# Team Update 10

# GAME AND SEASON MANUAL

Figure 3-24 CONTROL PANEL ROTATION CONTROL example

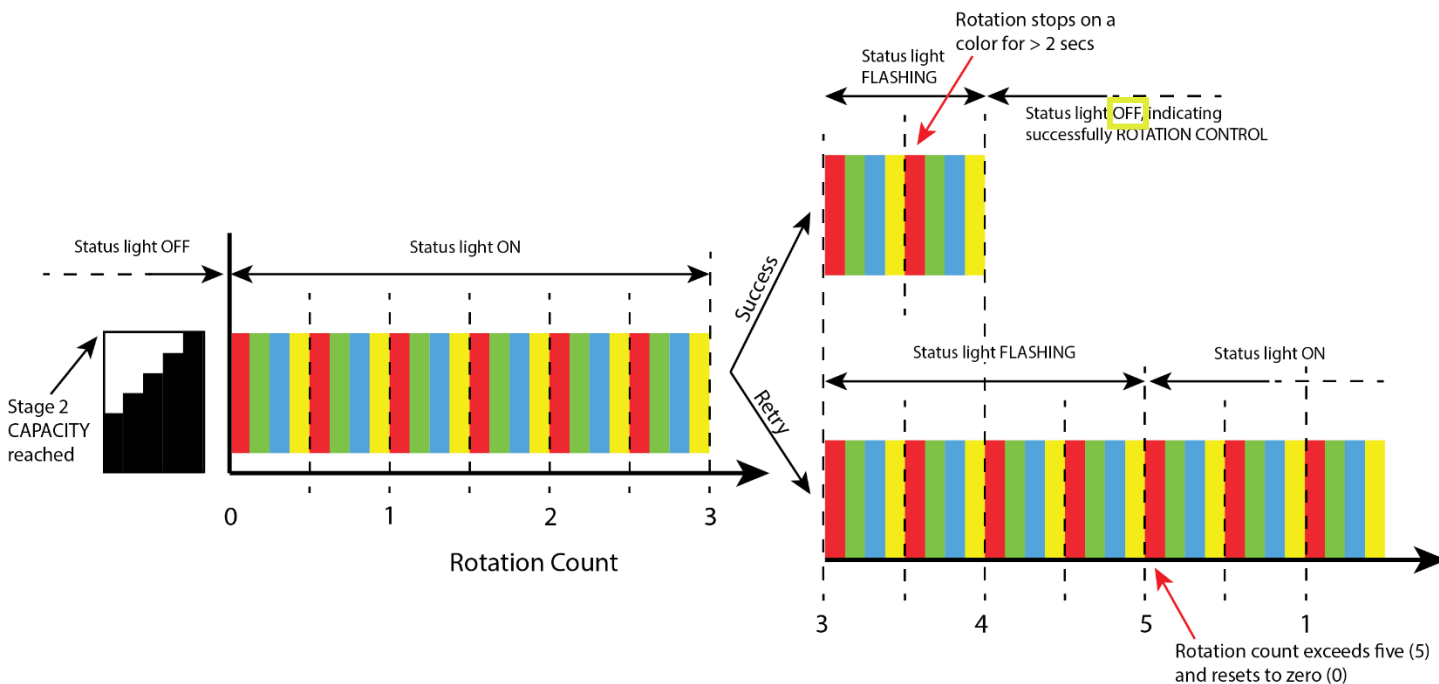
## 3.5.1 CONTROL PANEL
